SB-10055240-9683

Title: Prostar upper radiator pipe cracking or breaking at support bracket or at flange area

Applies To: Prostars built before 8/28/07

Drawing 1

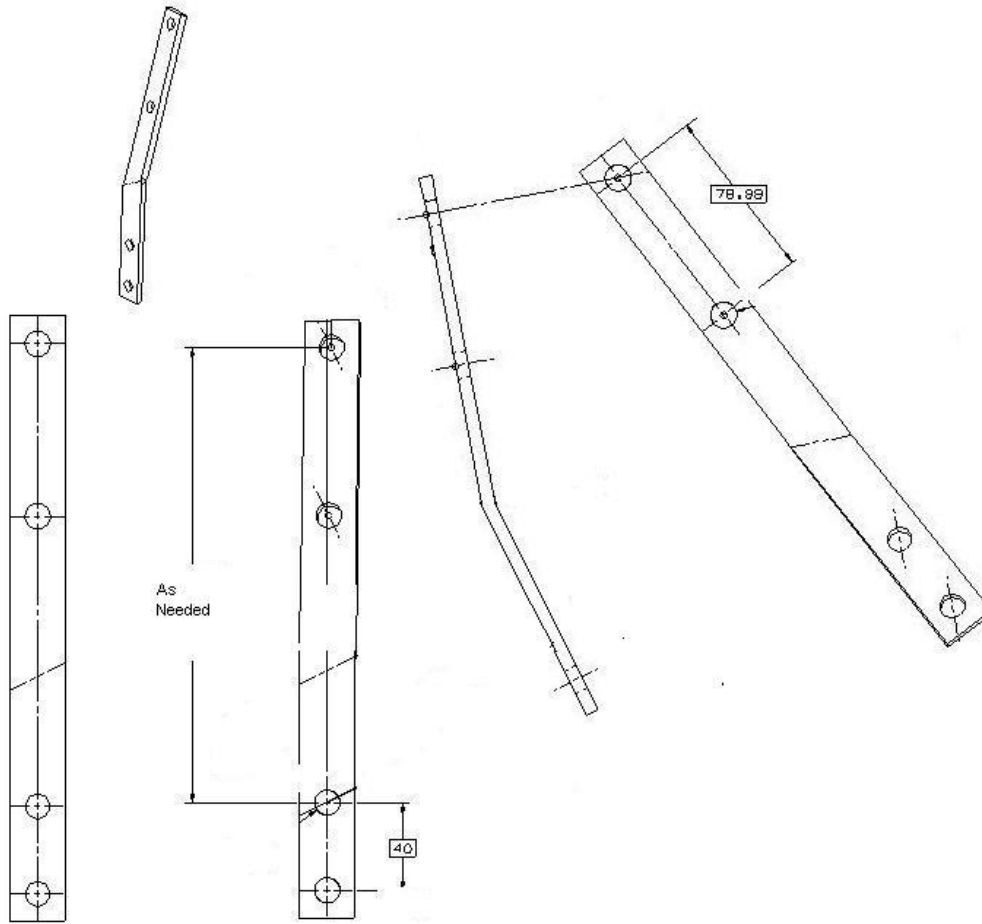
On some ProStar tucks built before 8/28/07 we have seen the upper radiator pipe break either at the support bracket that is welded to the pipe, or at the flange that mates to the engine. The fix is to cut off the support bracket that is welded to the pipe and make a simple bracket out of flat stock similar to drawing 1 below. Bolt the new bracket to the engine and secure the pipe to the bracket with an exhaust u-bolt (471200C1). Make sure to loosen the flange bolts and retighten them after all parts and hoses are loose-fit together and the pipe is secured to the bracket to prevent stress on the support bracket or flange. **This is an interim action to fix as fail until the kit is available.**

Note1: In the near future you will be able to order Kit number 8000893R91 along with New pipe number 3625914C2. This kit will contain the new support bracket, U-bolt, nuts, and washers necesseary to install the new pipe. Keep in mind that the new support bracket will not look like the bracket pictured below.

Kit 8000893R91 includes:

- 1 - 3821475C1 New support bracket
- 1 - 471200C1 U-bolt
- 2 - 25709R1 Washers
- 2 - 359783C1 Nuts
